REVISED RESPONSE TO REQUEST FOR ADDITIONAL INFORMATION

APR1400 Design Certification

RAI No.: 346-8434

SRP Section: 15.04.02 – Uncontrolled Control Rod Assembly Withdrawal at Power

Figure 1. Heat flux vs. Time (102% power level, 3.15 pcm/sec)

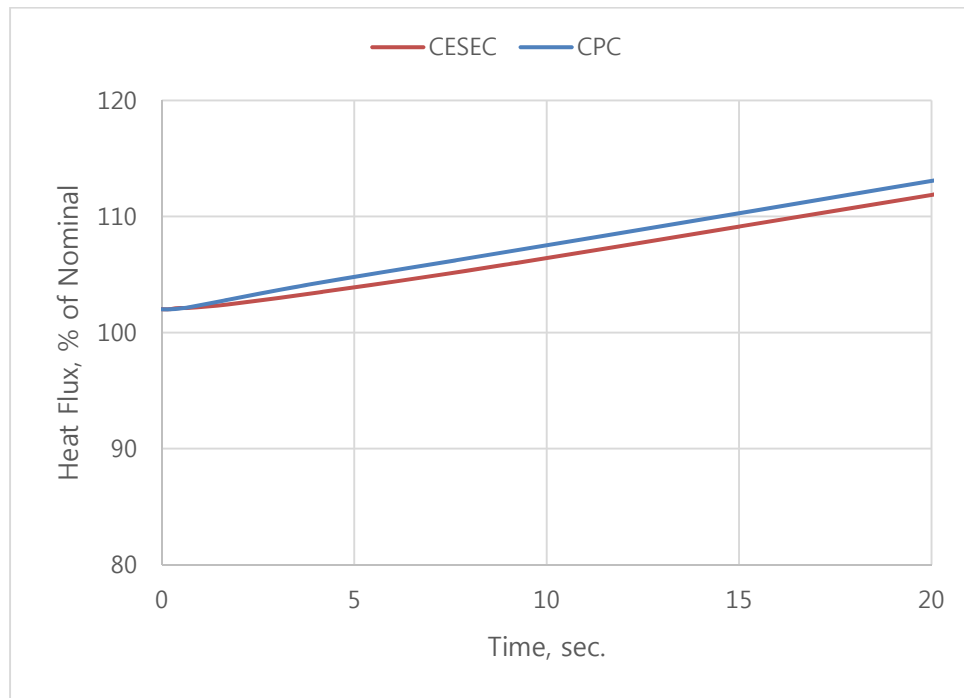
Please provide documentation supporting the assertion that ranges of power levels and reactivity insertion rates were examined for DCD Section 15.4.2, "Uncontrolled Control Element Assembly Withdrawal at Power." Please include results from any sensitivity analyses that were performed.

As shown in Figure 1 and Figure 2, the compensated heat flux, which is used for the DNBR calculation, is higher than the real heat flux. Therefore, the DNBR calculated by CPC is more conservative than the actual DNBR value.
